NAME	DATE	TITLE: Overall View			
DRAWN	PMG	1/22/2020				
CHECKED						
ENG APPR.						
MFG APPR.						
Q.A.			SIZE DWG. NO. REV B 2 ?			
COMMENTS:						
DO NOT SCALE DRAWING			SCALE: 1:20		WEIGHT:	SHEET 2 OF 31

NAME	DATE	TITLE: Dado		
DRAWN	PMG	1/22/2020			
CHECKED	RR	2/2/2020			
ENG APPR.					
MFG APPR.	RR	6/8/2020			
Q.A.			SIZE B		
COMMENTS:					
DO NOT SCALE DRAWING			DWG. NO. 4		REV A
			SCALE: 1:5		WEIGHT:

NAME	DATE	TITLE: Control Panel		
DRAWN	PMG	1/22/2020			
CHECKED	RR	2/2/2020			
ENG APPR.					
MFG APPR.	RR	6/8/2020			
Q.A.	PMG	10/7/2020	SIZE DWG. NO. REV B 14 C		
COMMENTS:					
DO NOT SCALE DRAWING					
SCALE: 1:5			WEIGHT:		SHEET 14 OF 31

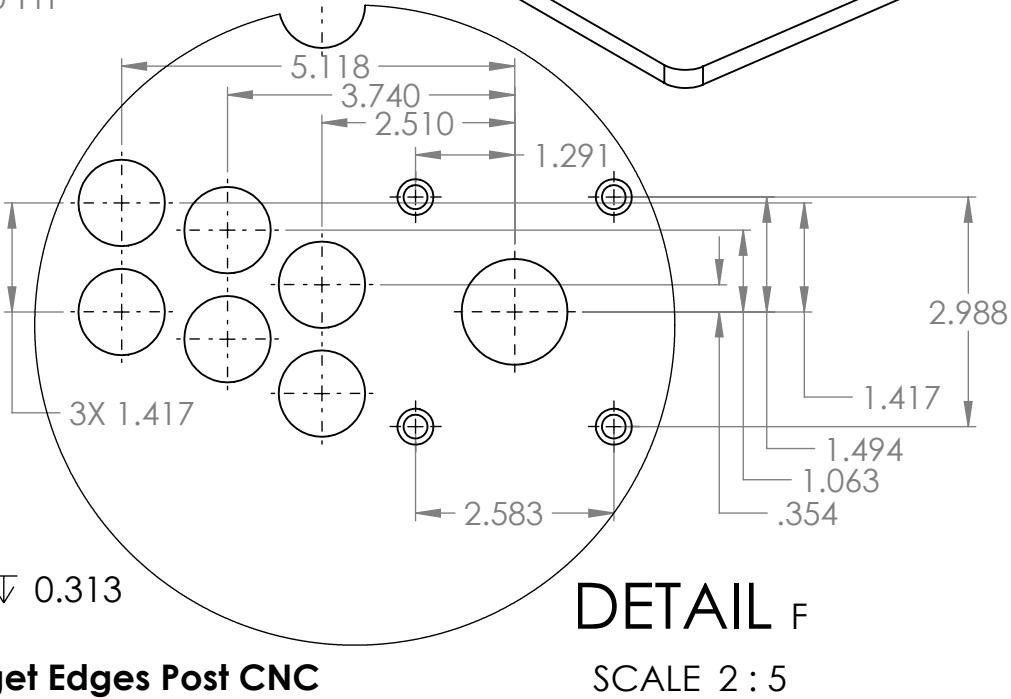
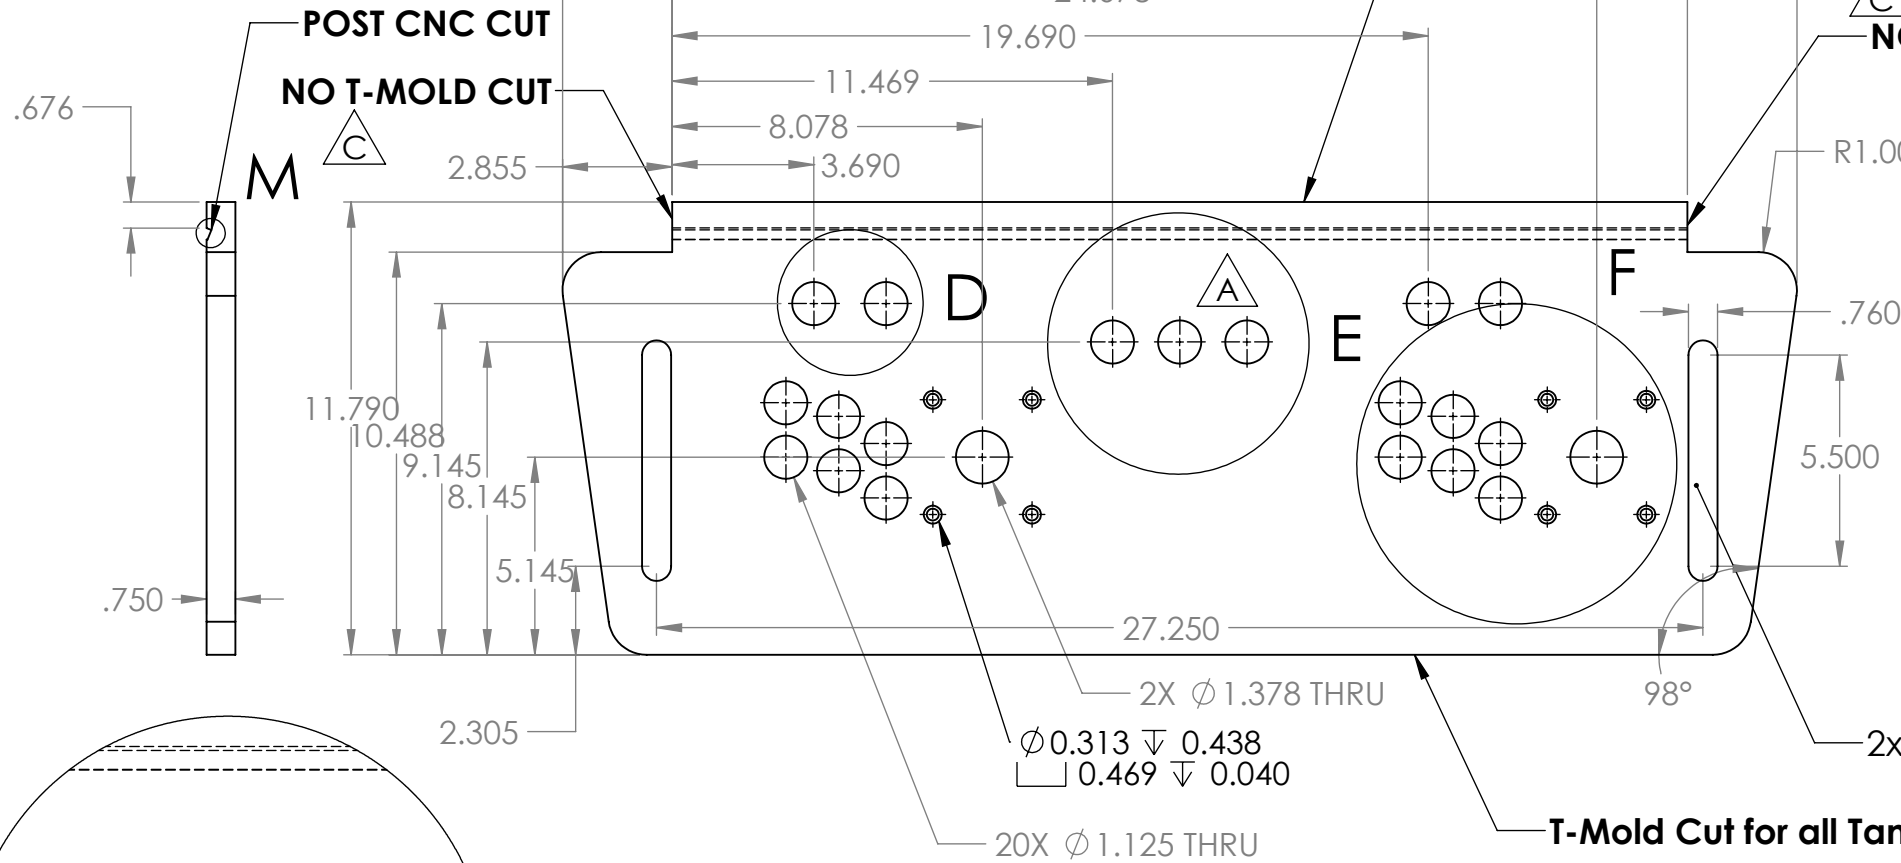
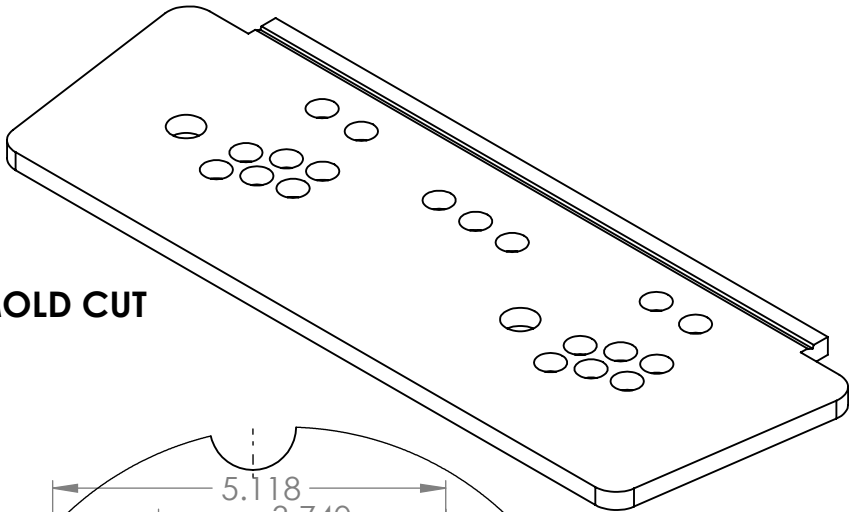
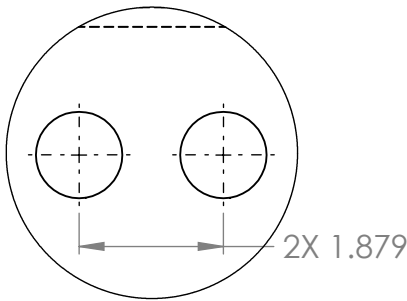
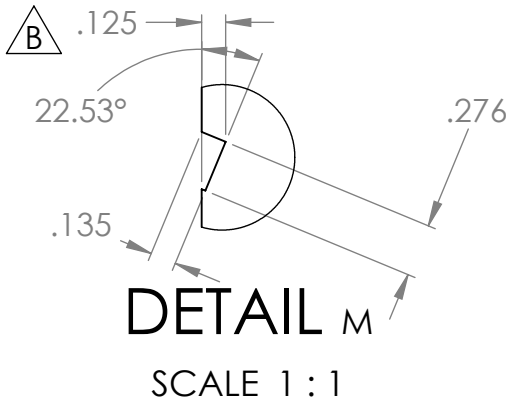
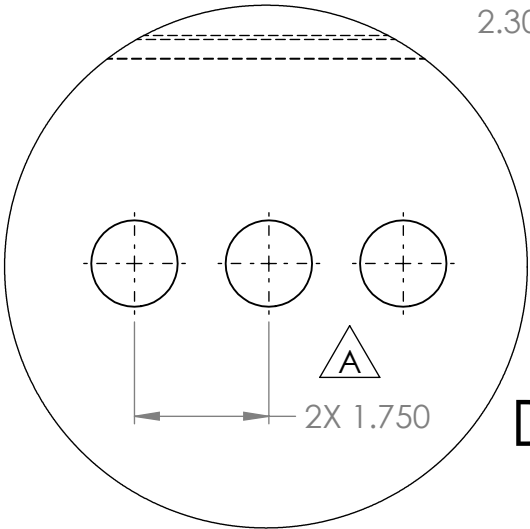
ZONE	REV.	DESCRIPTION	DATE	APPROVED
A4, B3	A	Reduced Holes from 4 to 3 and Chagned Spacing to be Centered/Symmetric	2/13/2020	PG
B3	B	Added Depth Dimension for the Plexi notch	10/8/2020	PG
B2, B4	C	Added NO T-MOLD CUT Note	2/6/2026	PG

NAME	DATE	TITLE: Latch Mount			
DRAWN	PMG	1/22/2020				
CHECKED	RR	2/2/2020				
ENG APPR.						
MFG APPR.	RR	6/8/2020				
Q.A.	PMG	10/7/2020	COMMENTS:			
DO NOT SCALE DRAWING			SIZE	DWG. NO.	REV	
			B	15	A	
			SCALE: 1:1	WEIGHT:	SHEET 15 OF 31

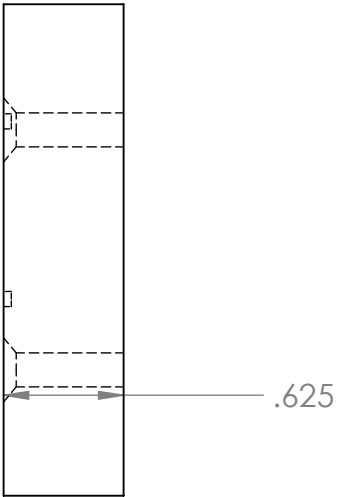
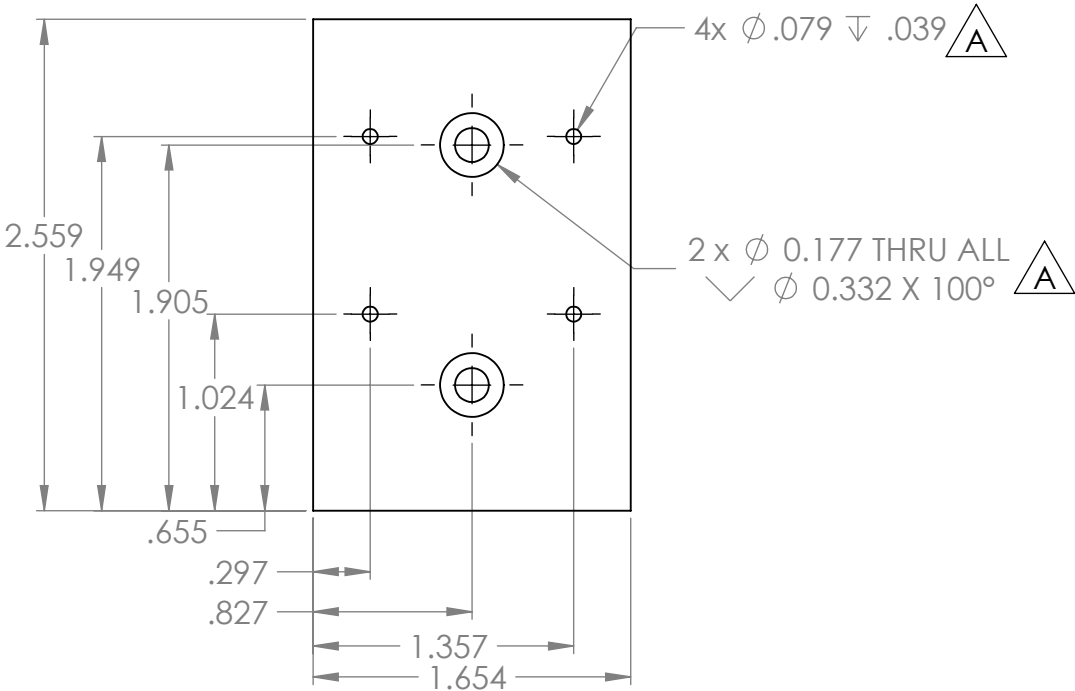
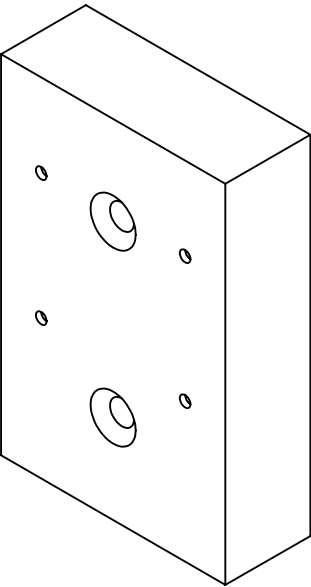
REVISIONS				
ZONE	REV.	DESCRIPTION	DATE	APPROVED
A2, B2	A	Added Depth Callout for Mounting Holes and Added 2x #8 Pan Head Screw Holes	11/3/2020	PG

NAME	DATE	TITLE: Cabinet Side Cleat		
DRAWN	PMG	1/22/2020			
CHECKED	RR	2/2/2020			
ENG APPR.					
MFG APPR.	RR	10/1/2020			
Q.A.					
COMMENTS:			SIZE B	DWG. NO. 17	REV A
DO NOT SCALE DRAWING			SCALE: 1:5	WEIGHT:	SHEET 17 OF 31

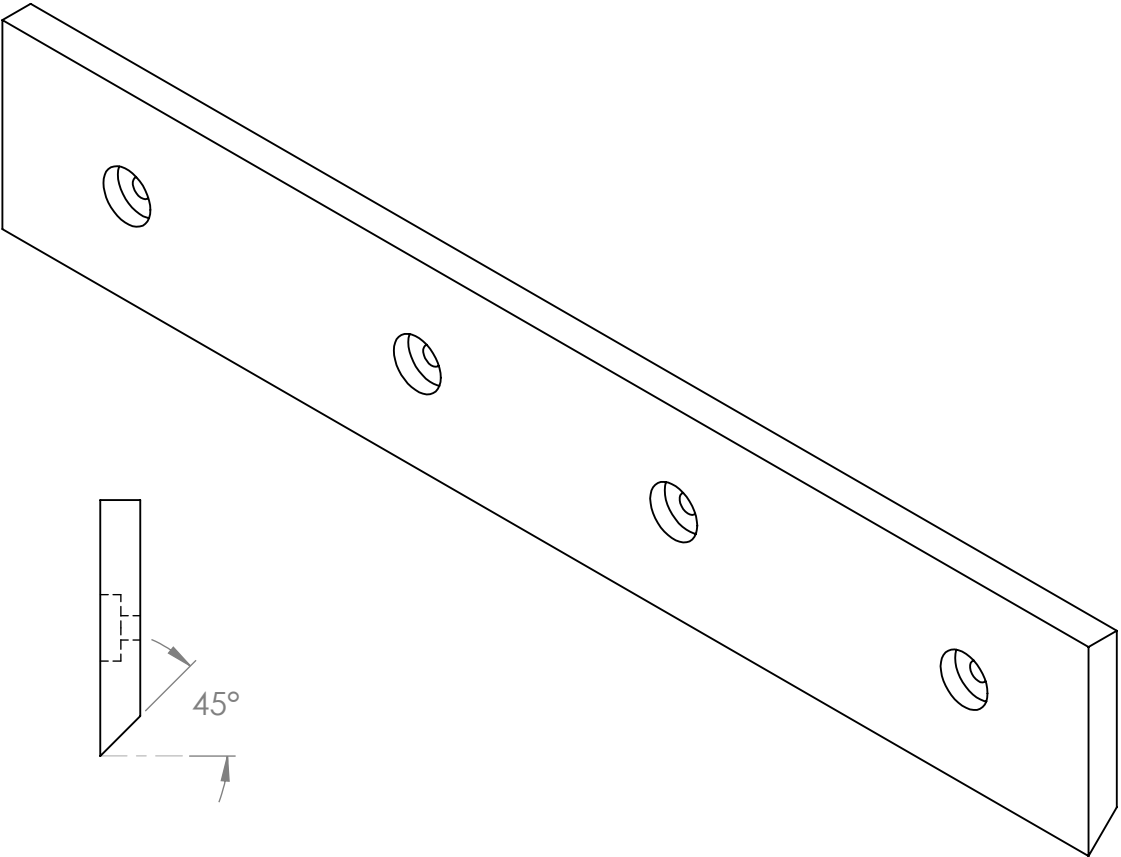
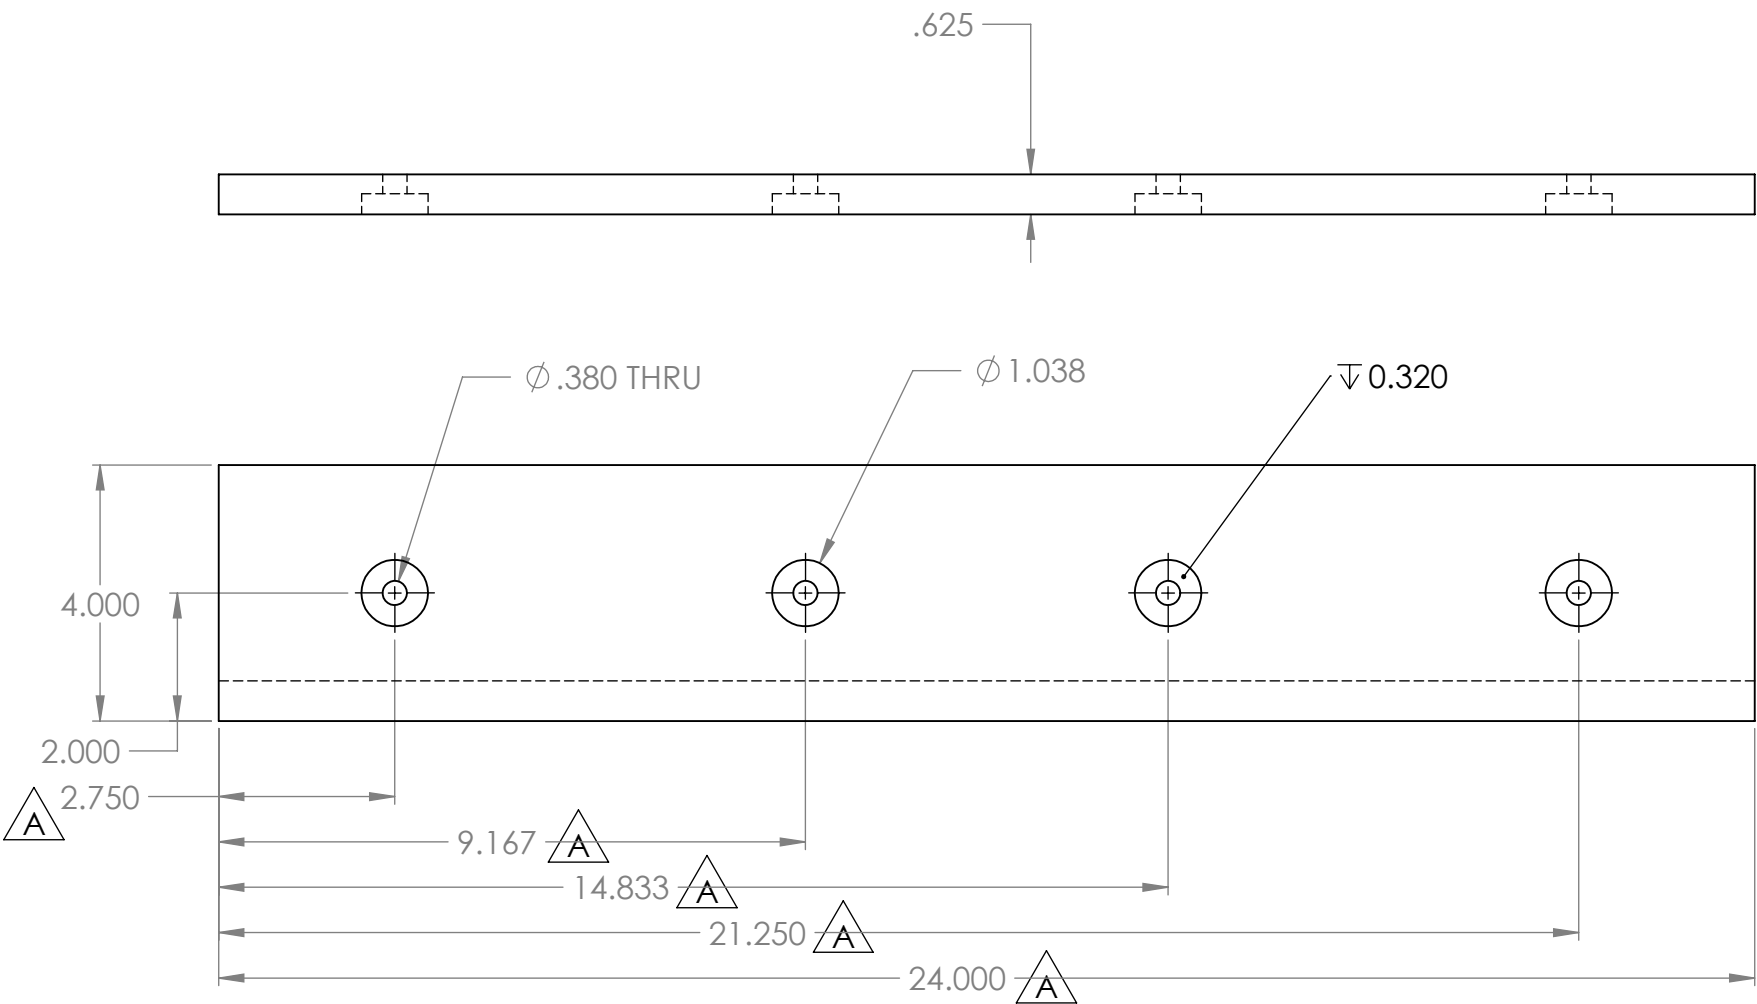
REVISIONS				
ZONE	REV.	DESCRIPTION	DATE	APPROVED
A3, A4	A	Changed the Length from 26 to 24, Moved Holes to Match the Hole Location Changes on the Back Panel	11/4/2020	PG

NAME	DATE	TITLE: Wall Side Cleat		
DRAWN	PMG	1/22/2020			
CHECKED	RR	2/2/2020			
ENG APPR.					
MFG APPR.	RR	10/1/2020			
Q.A.			SIZE B		
COMMENTS:					
DO NOT SCALE DRAWING			DWG. NO. 18		REV A
			SCALE: 1:5	WEIGHT:	SHEET 18 OF 31

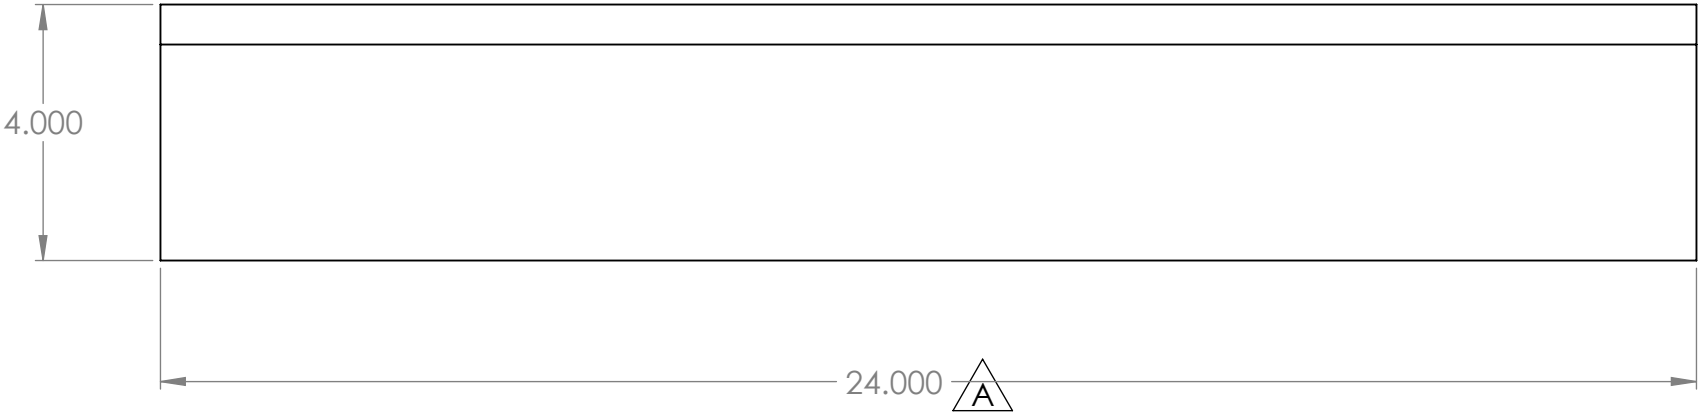
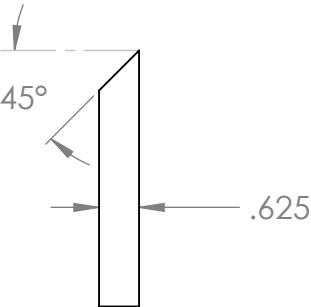
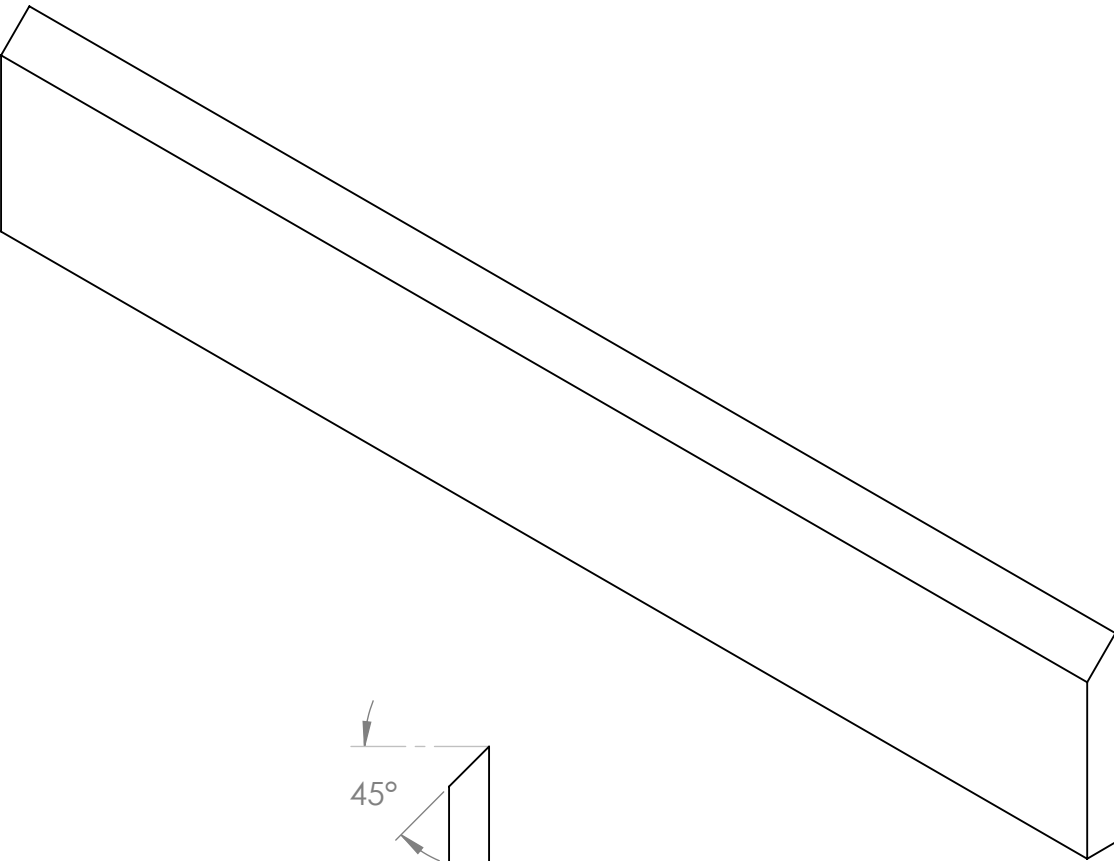
REVISIONS				
ZONE	REV.	DESCRIPTION	DATE	APPROVED
A3	A	Changed Length from 26 to 24	11/4/2020	PG

NAME	DATE	TITLE: Inside Cleat		
DRAWN	PMG	1/22/2020			
CHECKED	RR	2/2/2020			
ENG APPR.					
MFG APPR.	RR	10/1/2020			
Q.A.					
COMMENTS: DO NOT SCALE DRAWING			SIZE B	DWG. NO. 19	REV A
			SCALE: 1:5	WEIGHT:	SHEET 19 OF 31

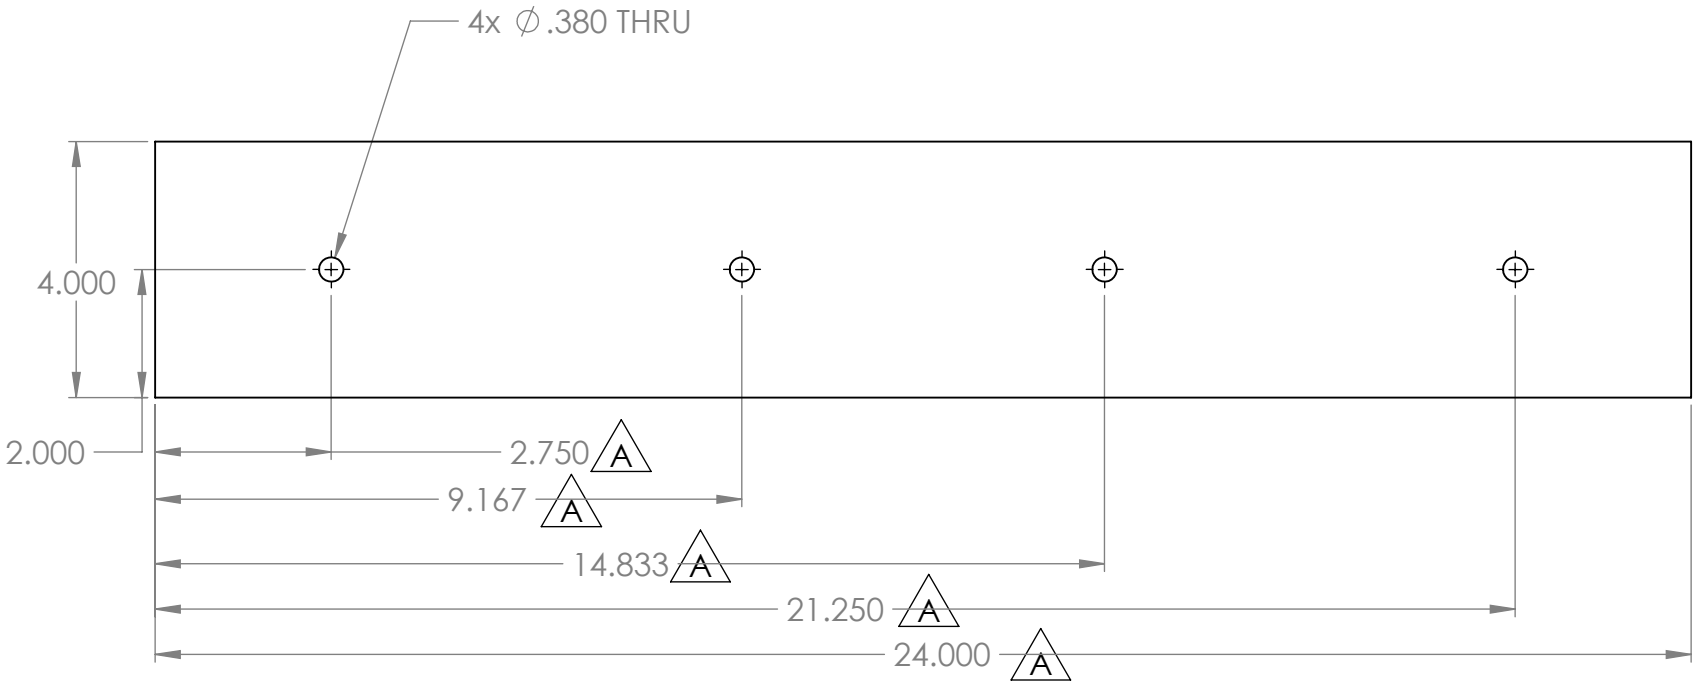
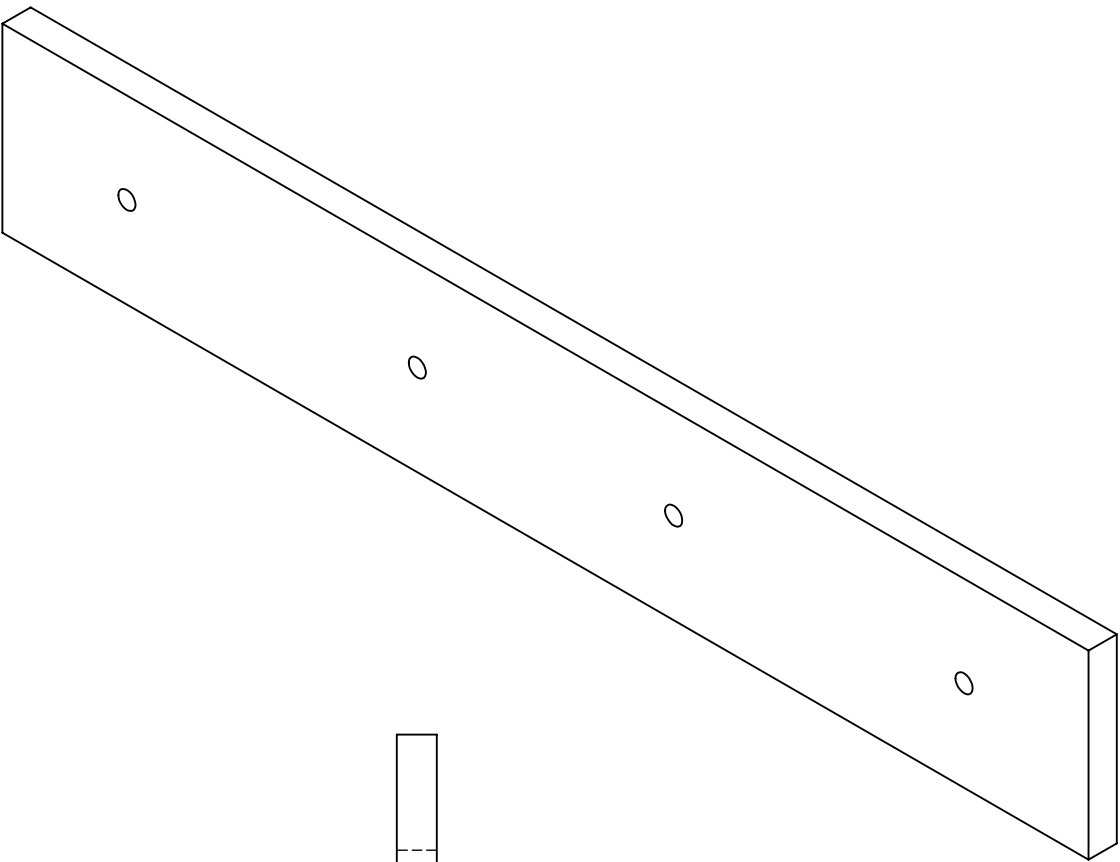
REVISIONS				
ZONE	REV.	DESCRIPTION	DATE	APPROVED
A3, A4	A	Changed the Length from 26 to 24, Moved Holes to Match the Hole Location Changes on the Back Panel	11/4/2020	PG
